### TOURING HEADLAMP RUBBER GASKET CHANGE

In mid-August 2007 there was a running change that commonized the two different headlamp assemblies on FLHT (Electra Glide) and FLHR (Road King) model motorcycles.

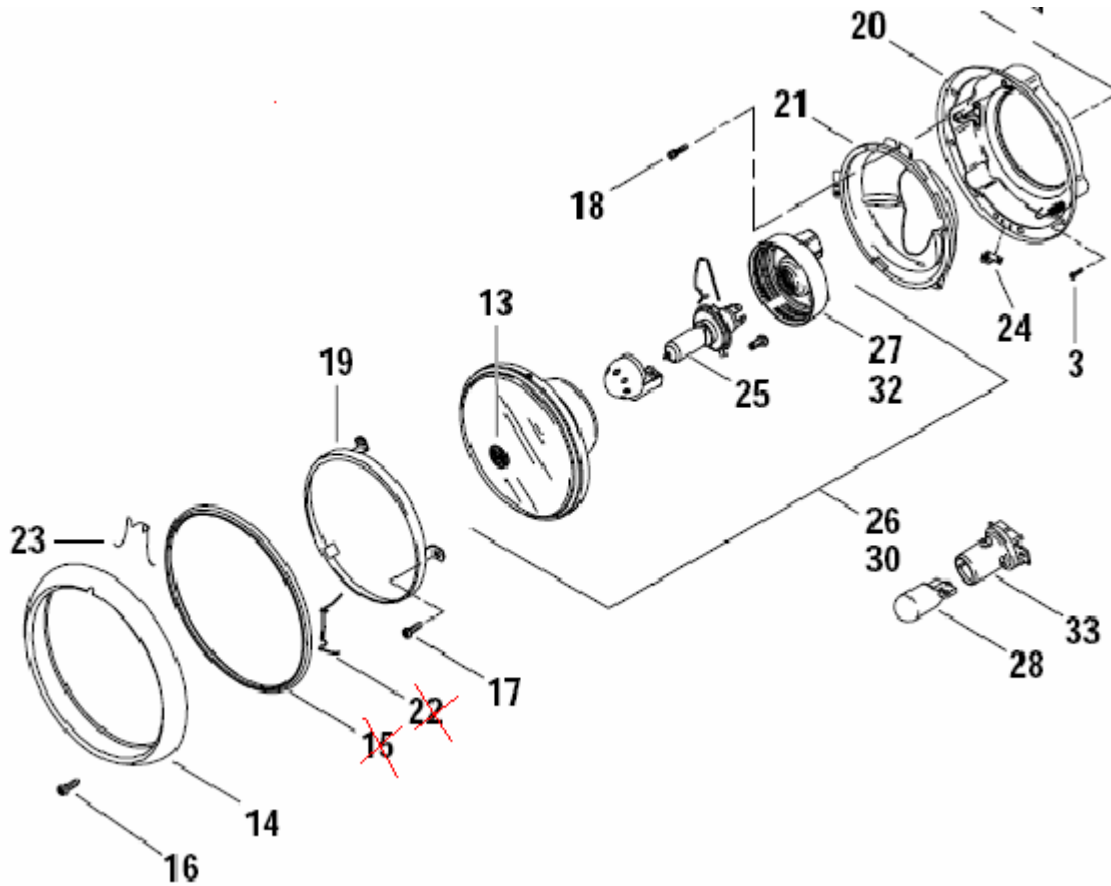
**Item 15 in the diagram below will no longer be used** on fairing models, along with 2 retaining clips, Item 22

One other less visible change also took place due to a supplier change for the headlamp assembly used in production. The retaining ring, Item 19 above, will appear to protrude a bit more and it will have a duller finish than the older version.
